SCOPE OF WORK

LCLS-II LERF as Cryomodule Testing Facility

POC: Kevin Jordan

Figure 1: LERF Second Floor

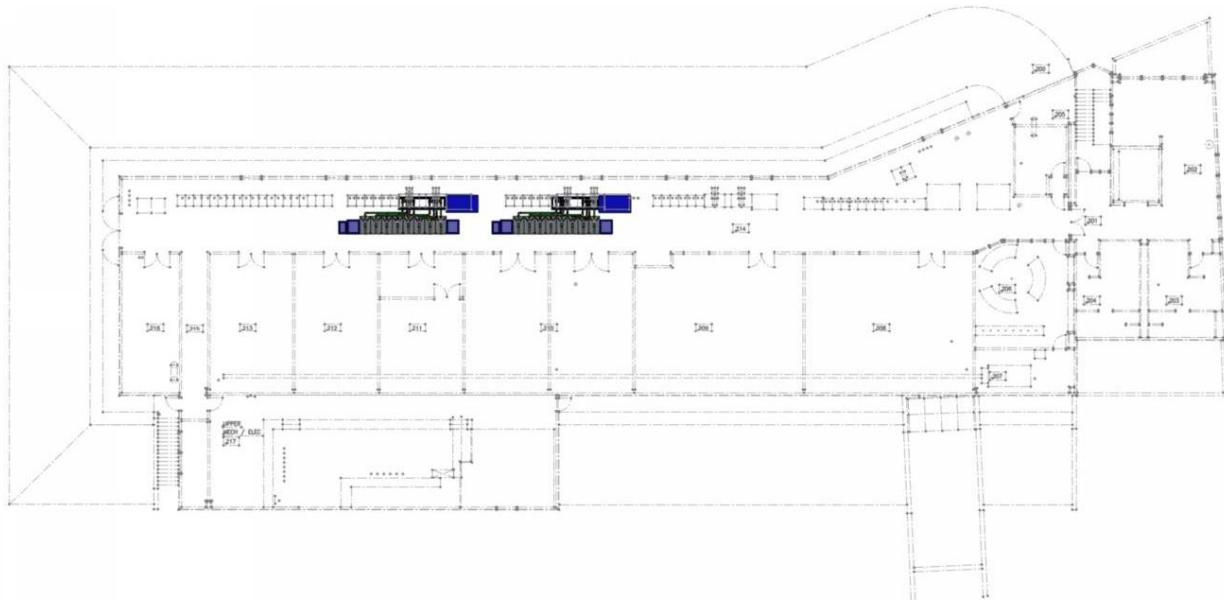
Using the NFPA Life Safety code, the second floor gallery means of egress was evaluated by Christine Snetter. The following conditions were established:

- New SSA's will be installed 18" in front of existing HPA/CPS's in two areas (see figure 1). The space between the new and existing equipment will be used for maintenance access only.
- The face of the new equipment will be 48" minimum from the existing south drywall partition.

Based on the described conditions, 48" of space in front of the equipment is adequate for the means of egress.

Exits are currently visible from both ends and no additional exit signs are expected to be required, however, the location of the exit signs will be re-evaluated after the equipment installation to determine whether an additional exit sign is required.
